Universe (CA91C042) Errata

Document Number: 8091042.ER601.02

Universe (CA91C042) Errata

Figure 1.1: BG3OUT# Circuit Solution

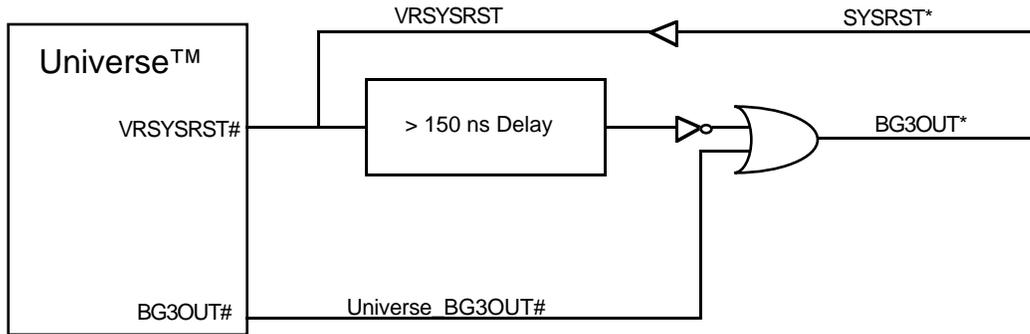
While the Universe is in system reset, it will directly propagate the values on its BGxIN# inputs to its BGxOUT# outputs. In most situations this will not cause any problems since the BGxIN# inputs are at a stable high value during reset. In slot 1, however, this is not the case. The inputs are not typically at stable high values, and in fact BG3IN# with its internal pull-down resistor is in a low state. At a minimum, this will result in a low state on the Universe's BG3OUT# during reset.

The BG3 daisy chain is used during reset by some VME interfaces, including Tundra's SCV64, for auto-syscon functionality. When the BG3IN# input is low, the VME interface will become the system controller.

Because the Universe in slot 1 will be propagating a low on BG3OUT#, a card in slot 2 with auto-syscon functionality may, along with the slot 1 Universe, become system controller. Problems may also be introduced if the slot 2 card is relying on stable high values on BG[2:0]IN*.

If the Universe is in slot 1, and the card in the next slot contains Auto System Controller functionality, its system controller functions will be enabled. The VME chassis will then have two cards as SYSCON and they will both try to arbitrate the VME bus with possible conflicts on the SYSCLOCK and BCLR* signals.

(1) Figure 1.1 is a circuit that can be built to mask the state of the Universe BGxOUT# signals during system reset. The circuit shows an implementation with BG3OUT# only. While SYSRST# is asserted, the inversion of the VRSYSRST# after the delay element, will mask the state of BG3OUT# during and for 150ns after SYSRST* assertion. The delay element is required since BG3OUT# may remain low for several CLK64 periods after release from reset. This can be implemented in any fashion that will delay the effect of SYSRST* negation for 150ns or greater. For other bus grant daisy chain signals, the circuit may be duplicated or 10k pull-ups may be placed on each of the BG[2:0]IN# to ensure the bus grant output remains high during reset.

**Figure 1.2: All Byte lanes enabled ---D32
 (Zero translation offset; VME Maximum data width is 32 bits)**

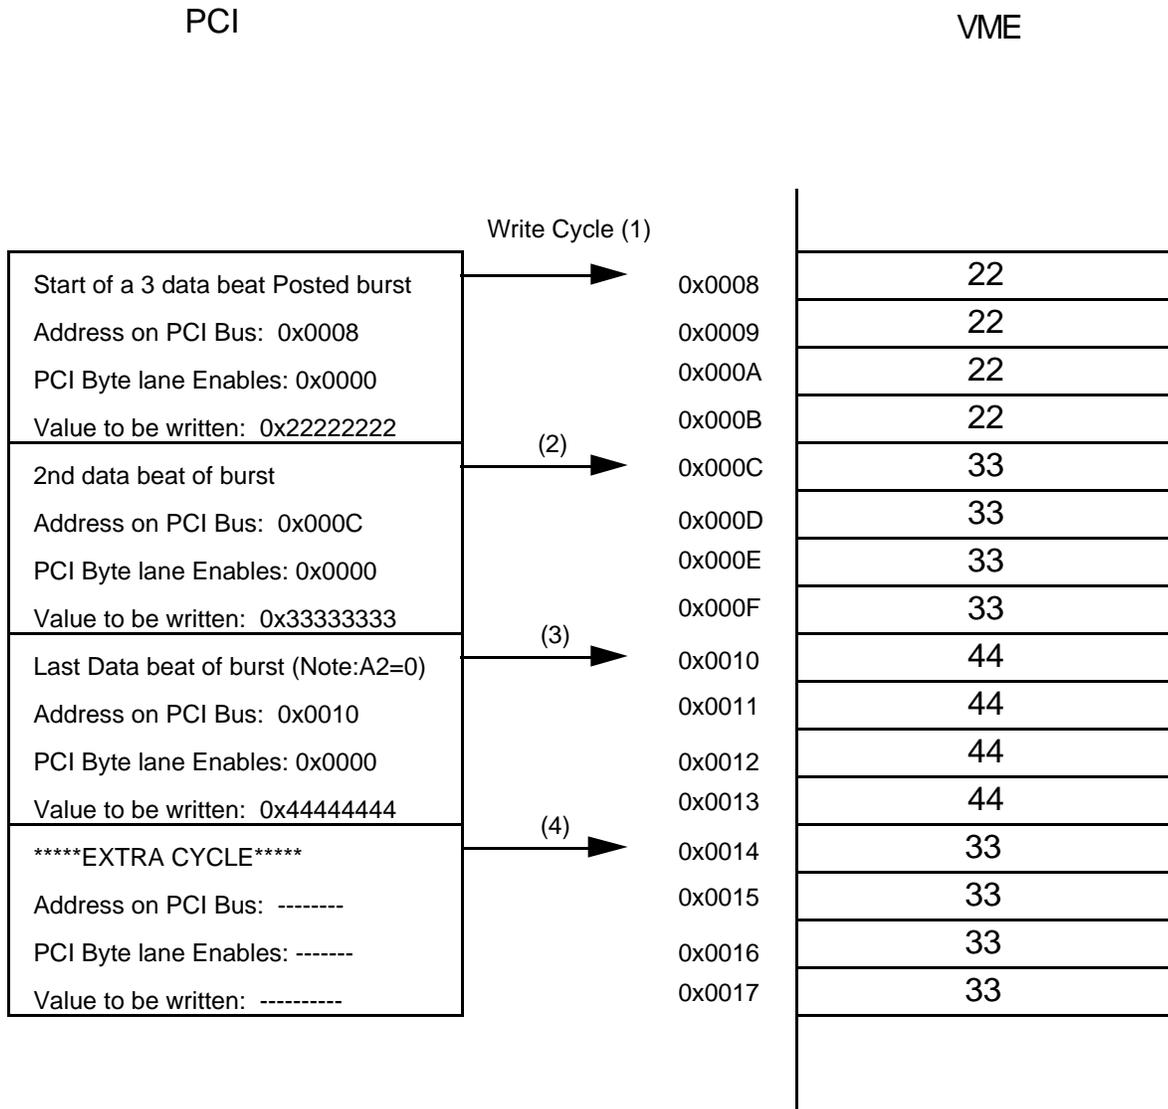
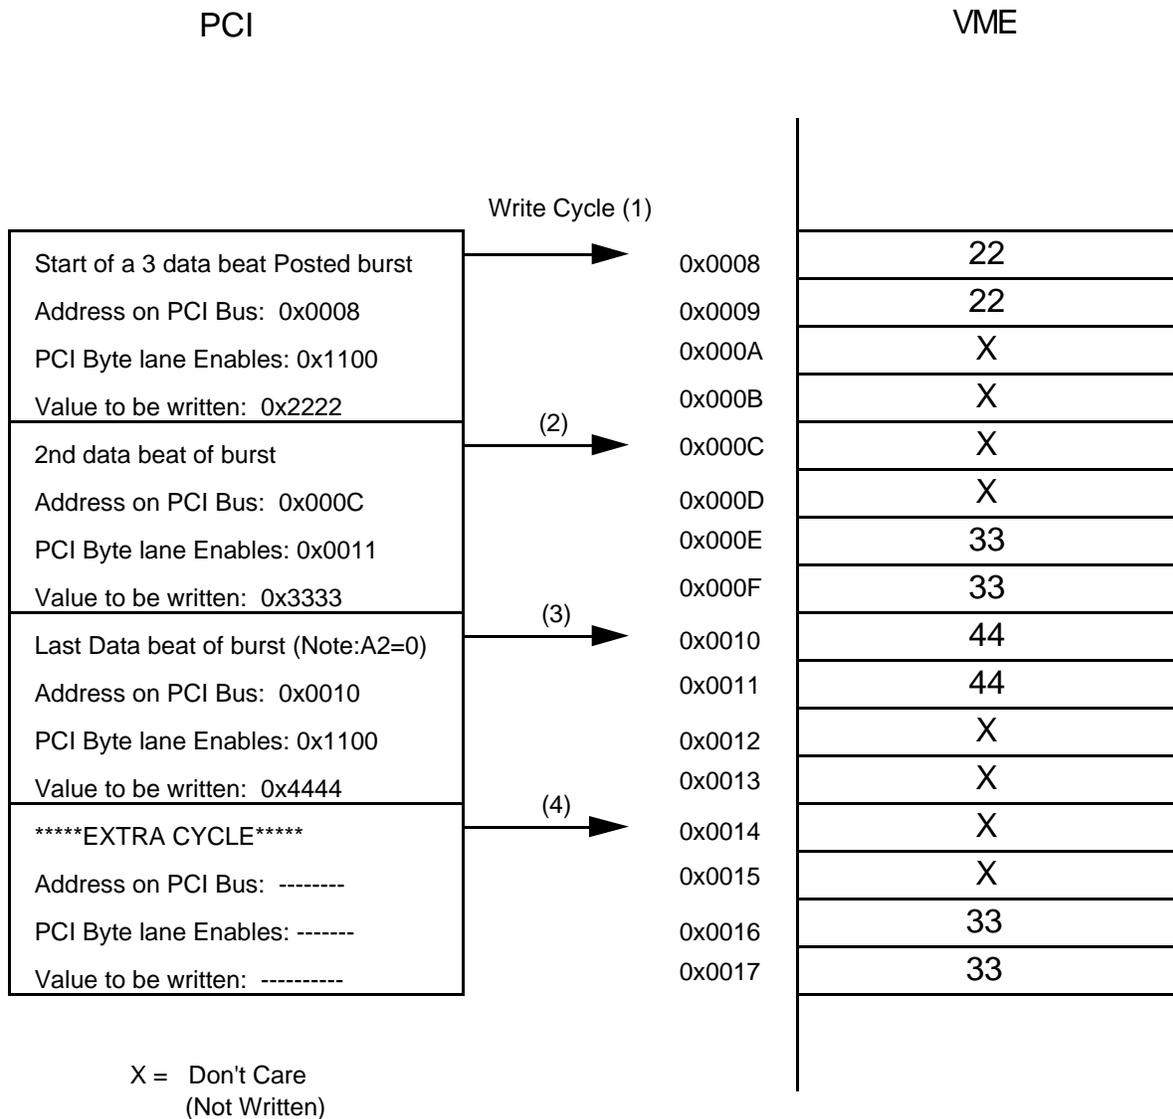
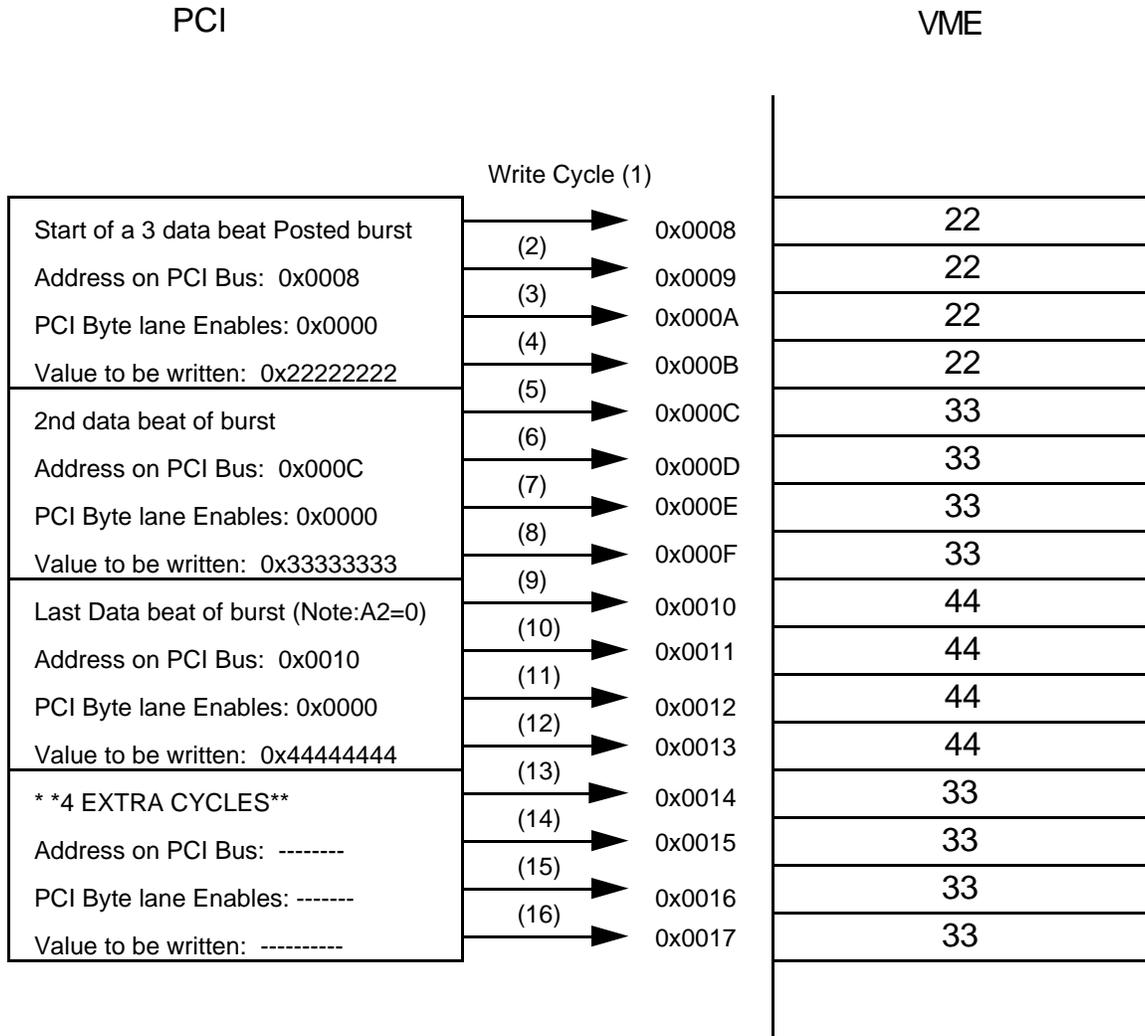
The Universe is designed to accept posted write bursts, from a PCI master, and transfer the data to the VMEbus. Under some conditions, when operating on a 32-bit PCI bus, the Universe may insert an extraneous data beat on the VME side. This will occur under the following conditions:

- operation on a 32-bit PCI bus
- posted (decoupled) write operations
- multiple data beat PCI transactions
- the last data beat of the burst has an address in which A2=0

When the above conditions are met, the Universe will dequeue the data from the FIFO onto the VME bus appropriately. However, an extraneous VMEbus write cycle will be generated. This extra write will be at an address 8 bytes higher than the second last data beat, and will contain data equal to that in the second last data beat. As with all PCI to VME transactions, if the accessed PCI slave image was set for a data width less than 32 bits, multiple VME cycles will be generated depending upon the number of byte lanes enabled for the second last data beat of the affected PCI transaction. Please refer to Figures 1.2-1.4 for an illustration of how this problem is manifested.

When all conditions for this errata are met, extraneous data will be written to the VME bus at an address beyond the block of data being written. If the data is being written to unused VME memory, then the user will perceive no impact. In other situations, valid data will be overwritten by this operation. If the extraneous data is written to the control register of some device, the state of the system could be altered.

- (1) Ensure that all burst transactions on PCI to the Universe are 64-bit aligned to ensure that the last data beat of the burst does not have an address in which A2=0.
- (2) Since the problem only arises during decoupled operation, avoid posted writes. This may be done on a per PCI slave image basis, allowing the usage of the faster decoupled operation in some slave images for transactions that will not encounter the problem, or where its impact is not of concern.
- (3) Use single beat transactions only. The error only occurs on multiple data beat bursts through the local PCI slave channel. This has the potential impact of lower overall performance and increased PCI bus bandwidth utilization.
- (4) Use the Universe DMA engine to move the data from PCI to VME.
- (5) Use 64-bit PCI operation whenever possible.

Figure 1.5: Release When Done IRQ workaround

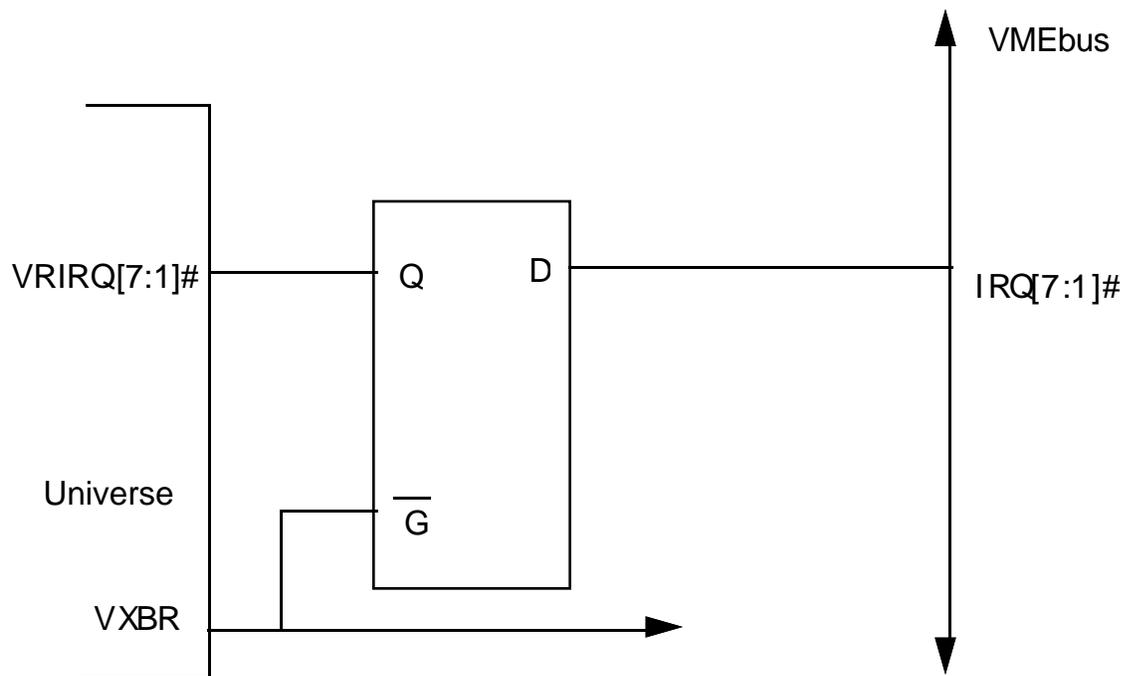
As a VME interrupt handler, the Universe is designed to monitor any or all of the VMEbus interrupt levels simultaneously. However, in one particular scenario of events, the Universe could generate an IACK cycle on the VMEbus at an incorrect level. In addition, the interrupt channel could lock up preventing further generation of IACK cycles until the Universe is reset. This errata will manifest itself when all of the following conditions occur in sequence:

- The Universe receives an interrupt on one of its VRIRQ lines.
- The Universe, as an interrupt handler, requests the VME bus in order to execute its IACK cycle. (VXBR)
- The Universe receives another interrupt, at a higher level than the first, immediately before it executes its IACK cycle for the lower level interrupt. (VIACKOUT#)

- 1) The Universe will generate an IACK cycle on level zero, irrespective of the intended level. In addition, the Universe will not be able to handle further incoming VME interrupts until the next reset. The system could generate a VME bus error, lose a high level interrupt, and the ability to map VME interrupts to the PCI bus. All other activity including interrupt generation by the Universe remains operational.
- 2) The Universe will perform the higher level IACK cycle, but will store the status/ID in the register for the lower level interrupt. This would cause significant confusion for the PCI resource delegated to handle the interrupt. In this case the Universe will continue to handle further interrupts.

- 1) With the Universe's requester placed in Release When Done mode (RWD), a transparent latch can be used to gate the incoming IRQ lines. This gating technique will prevent the Universe from seeing an interrupt during the vulnerable error window. This hardware workaround will not work when the requester is in Release On Request mode (ROR). Please see Figure 1.5.

Figure 1.7: Errata #19 workaround

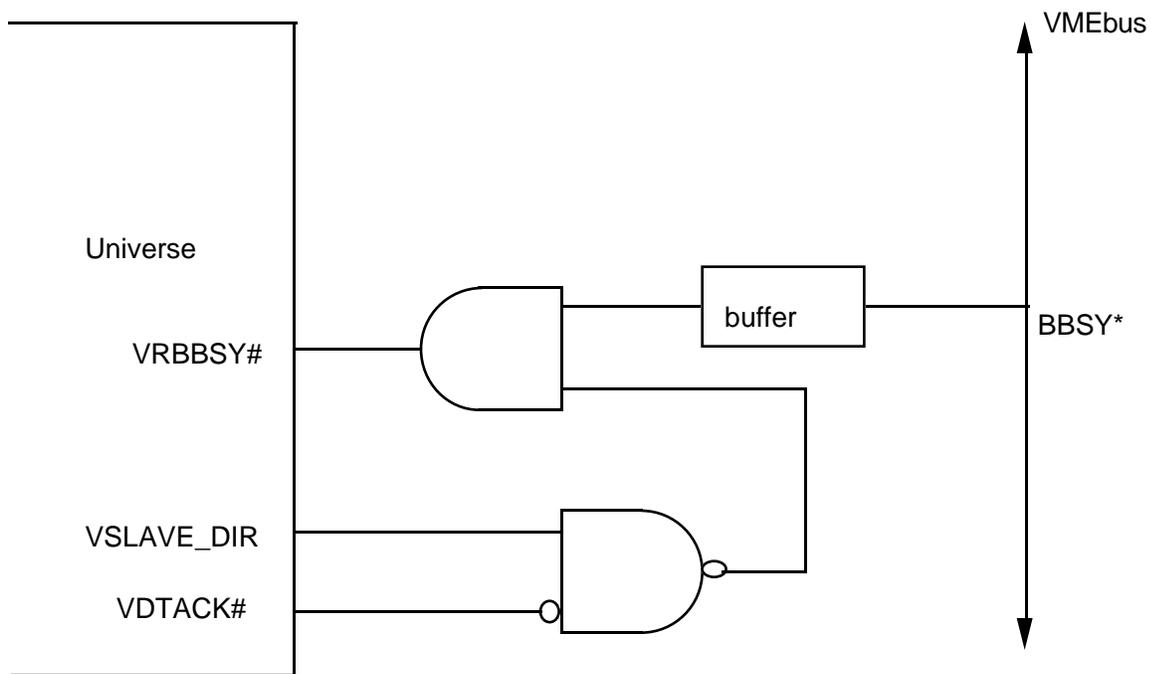
The Universe is designed to execute posted write cycles through its VME slave channel. During these cycles, the Universe queues data into its internal FIFO (RXFIFO). When the FIFO is filled, the Universe will hold DTACK* asserted. DTACK will remain asserted until an entry is dequeued onto the PCI bus.

If the Universe requests and becomes the VME master immediately after that FIFO full condition, and before any entries have been dequeued onto the PCI bus, the erroneous behaviour, described below, may occur.

If the Universe becomes the VME master and prepares to generate an IACK cycle while it is still asserting DTACK* (due to the FIFO full condition), the address of the last entry posted into the RXFIFO becomes corrupted. The address is substituted with 0x320. The IACK cycle continues on the VME side as normal once DTACK is negated by the Universe.

If an external PCI master attempts to perform a coupled cycle through the Universe and the Universe gains ownership of VME while the Universe's is still asserting DTACK* (due to the FIFO full condition) a deadlock could occur. The VME side of the cycle cannot begin because the Universe has not released the DTACK* signal. DTACK* will only be released once there is room in the RXFIFO, however, this room cannot be created until the PCI initiated cycle completes, freeing up the PCI bus. The result is a deadlock condition hanging both VME and PCI buses.

Both manifestations of this errata can be solved by implementing the hardware schematic shown in Figure 1.8.
